BURLINGTON DEVELOPMENT REVIEW BOARD Tuesday, March 17, 2015, 5:00 p.m. Contois Auditorium, City Hall, 149 Church Street, Burlington, VT AGENDA

To: Development Review Board
From: Mary O'Neil, AICP, Senior Planner
Date: March 17, 2015
RE: 20 Pine Street ZP15-0803CA

To: Development Review Board
From: Mary O'Neil, AICP, Senior Planner
Date: March 17, 2015
RE: ZP15-0810SP 10 University Place

General Plan
1 of 2

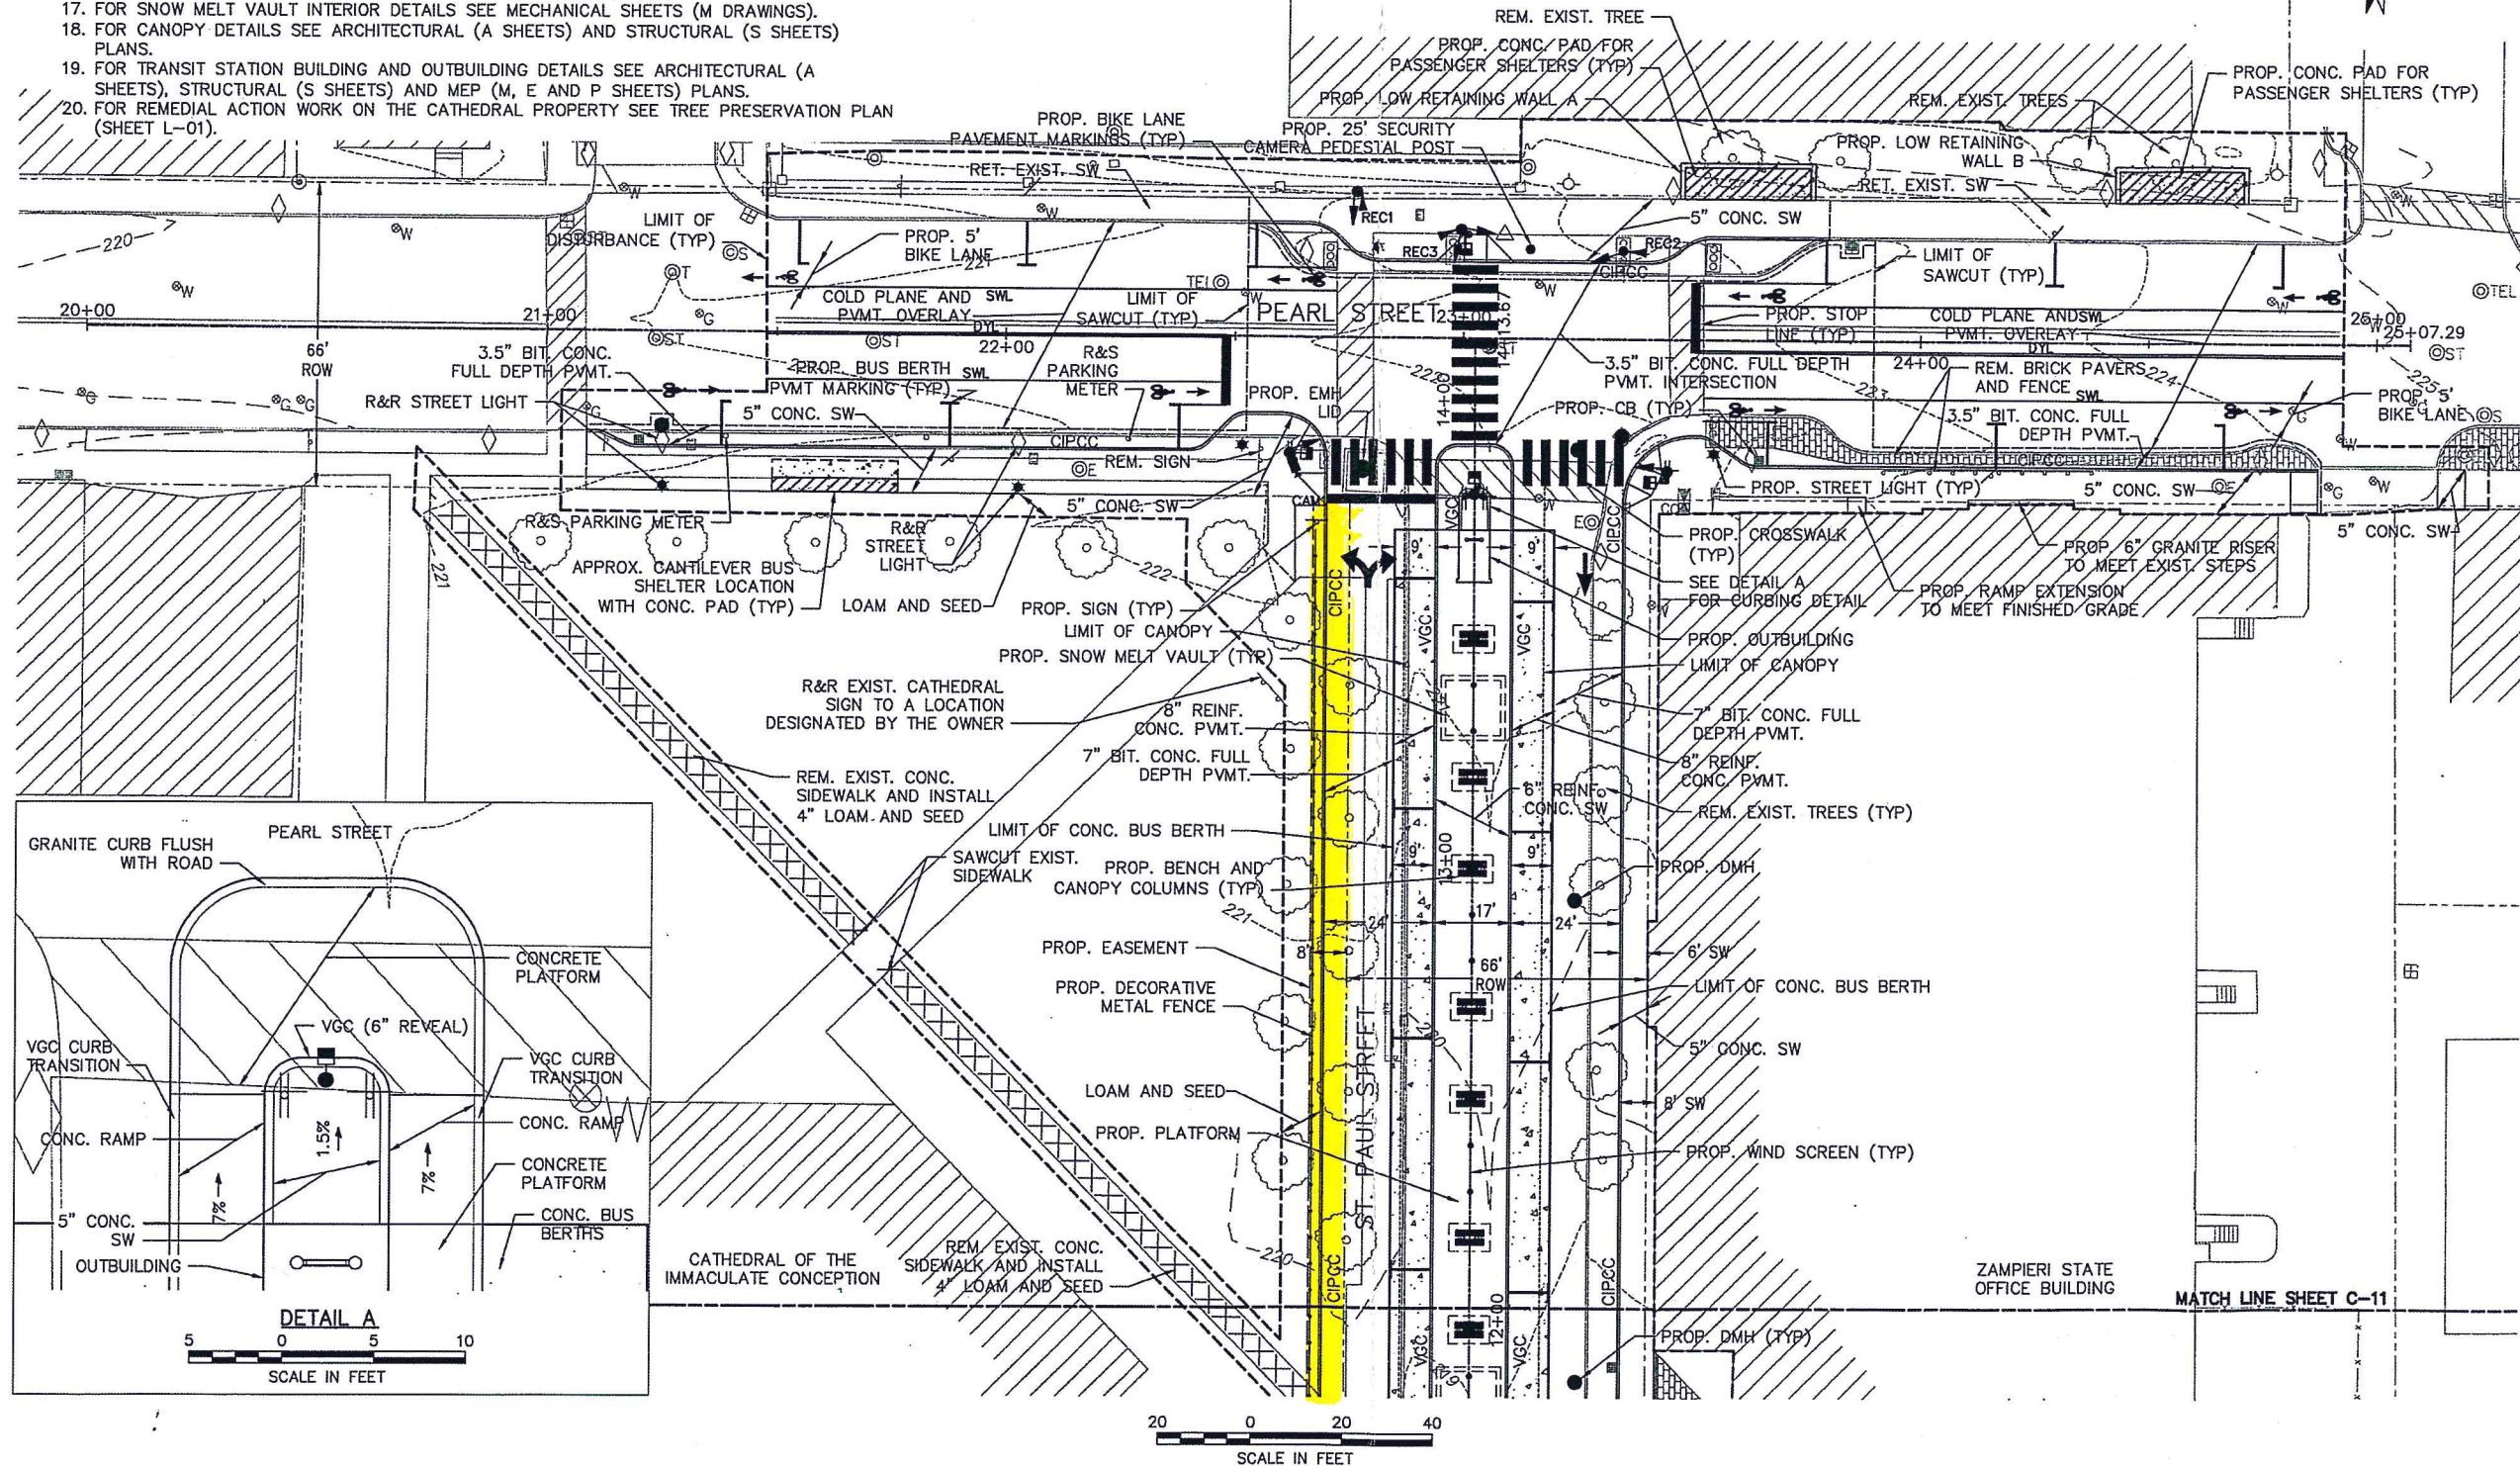
Brad Rabinowitz – Some concern about taking property away from the Cathedral, landscaping part of it. Plan does not show trees that are there. A fence is being proposed, but not part of this application.

Steve Carlson – the trees are within the public ROW. We will be doing pruning, re-planting missing trees, aerate the soil, add plant and animal fiber; doing extensive landscape restoration.

Drawing Title
Existing Conditions Plan

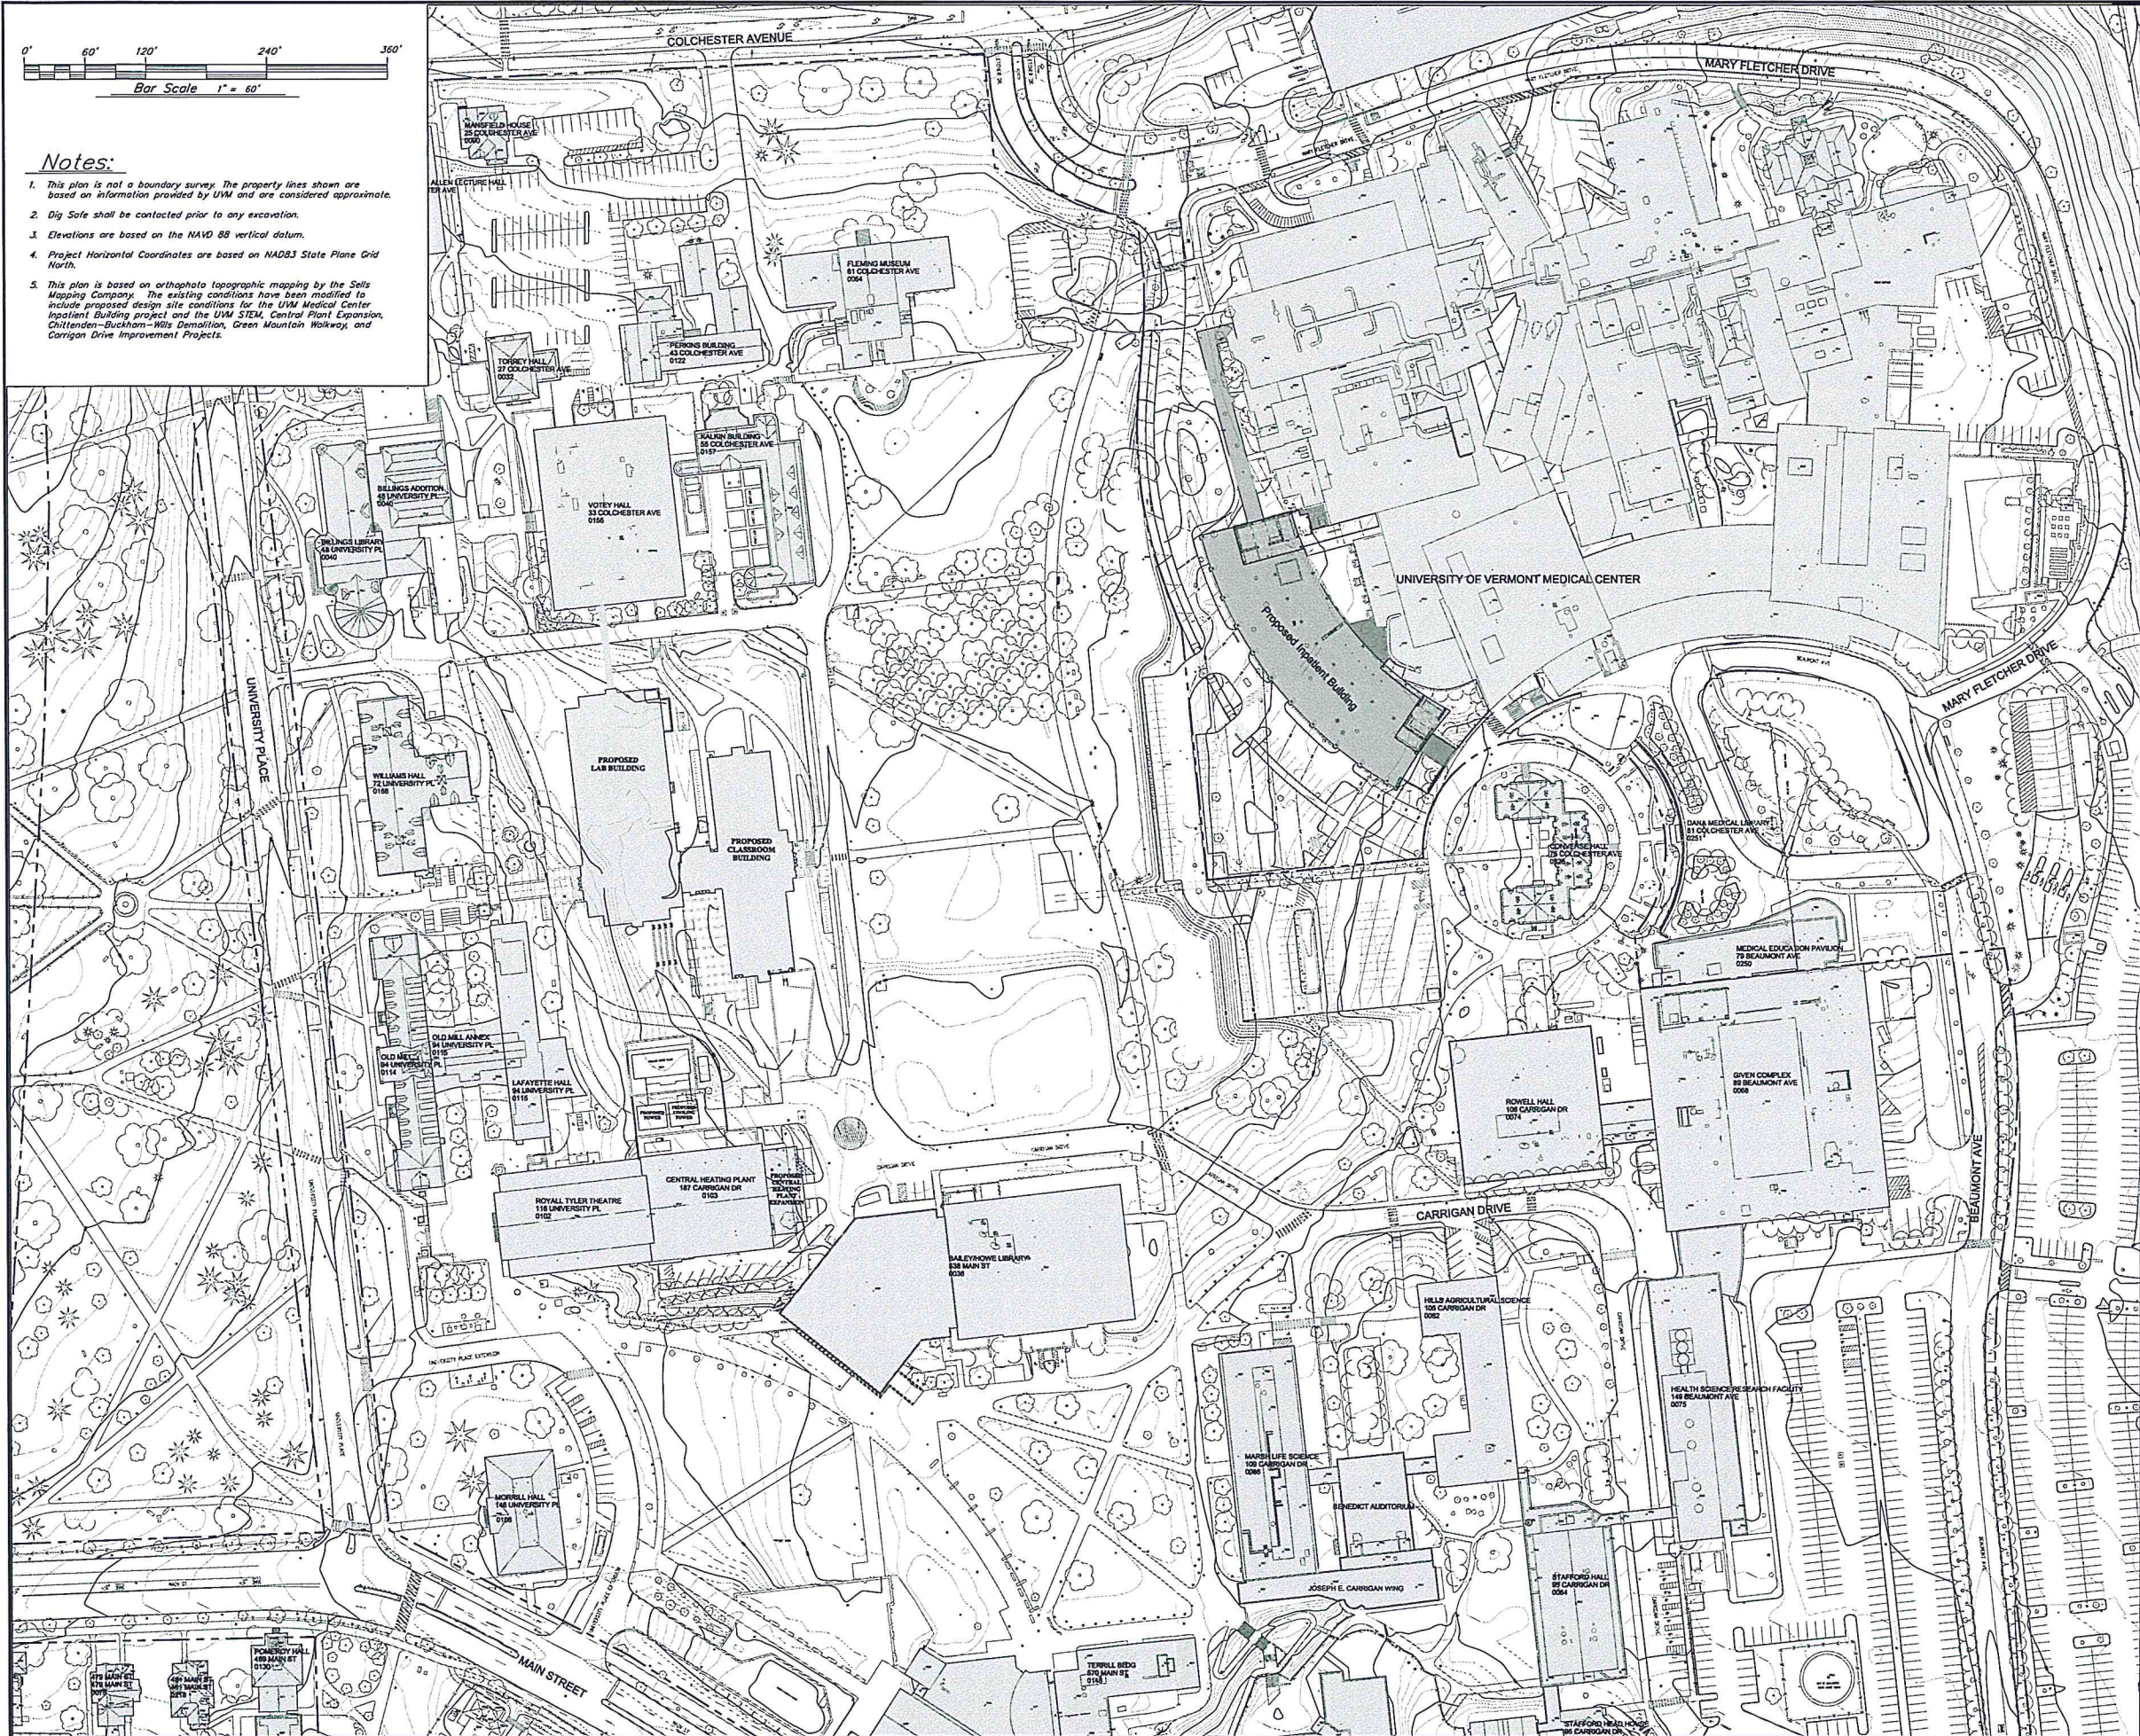
Submission information does not define existing landscaping; however contour lines suggest a fairly rapid change of grade at the southeast corner of the project area. Final application should include details as to existing and proposed landscaping, site grades, and proposed alteration.
